Product Change Notice: Various EVQ-Q2 and EVQ-P0 Series Tactile Switches

PCN.PG13.9.10.2020

9.10.2020

Panasonic PCN.PG13.9.10.2020 Change Details

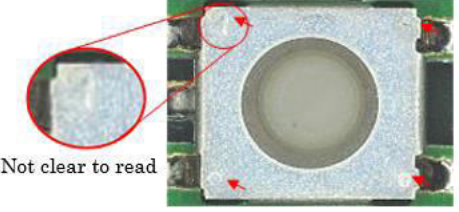
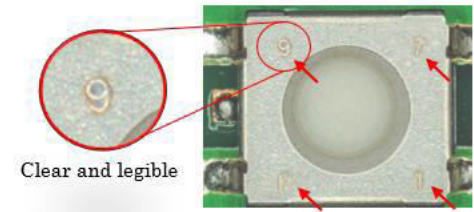
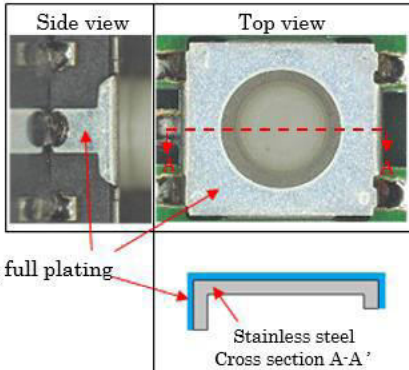
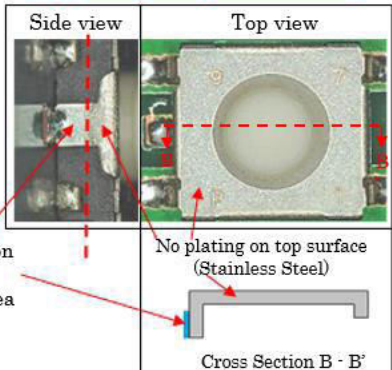
Change Content	Current type	New type																											
Date Code Display	<p><u>Marking by punch</u></p>  <p>Not clear to read</p>	<p><u>Marking by laser</u></p>  <p>Clear and legible</p>																											
Marking content	<p><u>Not specified day and machine number</u></p>  <table border="1" data-bbox="503 777 852 913"> <thead> <tr> <th>Mark</th> <th>Indication</th> <th>Example</th> </tr> </thead> <tbody> <tr> <td>Y</td> <td>Produced Year</td> <td>2020 → 0</td> </tr> <tr> <td>M</td> <td>Produced Month</td> <td>Jan~Sep → 1~9 Oct → 0, Nov → N, Dec → D</td> </tr> <tr> <td></td> <td>Product Date</td> <td>① The first ten days of a month ② The middle of the month ③ The last ten days of the month</td> </tr> </tbody> </table>	Mark	Indication	Example	Y	Produced Year	2020 → 0	M	Produced Month	Jan~Sep → 1~9 Oct → 0, Nov → N, Dec → D		Product Date	① The first ten days of a month ② The middle of the month ③ The last ten days of the month	<p><u>Specified production day and machine number</u></p>  <table border="1" data-bbox="1088 766 1412 913"> <thead> <tr> <th>Mark</th> <th>Indication</th> <th>Example</th> </tr> </thead> <tbody> <tr> <td>Y</td> <td>Produced Year</td> <td>2020 → 0</td> </tr> <tr> <td>M</td> <td>Produced Month</td> <td>Jan~Sep → 1~9 Oct → 0, Nov → N, Dec → D</td> </tr> <tr> <td>D</td> <td>Produce Day</td> <td>1st~9th → 1~9, 10 → 0 11th~31st → A~W (without I,O)</td> </tr> <tr> <td>M/C</td> <td>Machine No.</td> <td>M/C No.1 → 1 ...</td> </tr> </tbody> </table>	Mark	Indication	Example	Y	Produced Year	2020 → 0	M	Produced Month	Jan~Sep → 1~9 Oct → 0, Nov → N, Dec → D	D	Produce Day	1st~9th → 1~9, 10 → 0 11th~31st → A~W (without I,O)	M/C	Machine No.	M/C No.1 → 1 ...

Mark	Indication	Example																											
Y	Produced Year	2020 → 0																											
M	Produced Month	Jan~Sep → 1~9 Oct → 0, Nov → N, Dec → D																											
	Product Date	① The first ten days of a month ② The middle of the month ③ The last ten days of the month																											
Mark	Indication	Example																											
Y	Produced Year	2020 → 0																											
M	Produced Month	Jan~Sep → 1~9 Oct → 0, Nov → N, Dec → D																											
D	Produce Day	1st~9th → 1~9, 10 → 0 11th~31st → A~W (without I,O)																											
M/C	Machine No.	M/C No.1 → 1 ...																											
Related Part Change (Metal Cover)	<p><u>Ag full plating on metal cover</u></p>  <p>Ag full plating</p> <p>Stainless steel Cross section A-A'</p>	<p><u>Ag partial plating on metal cover</u></p>  <p>Ag plating on ground terminal area</p> <p>No plating on top surface (Stainless Steel)</p> <p>Cross Section B-B'</p>
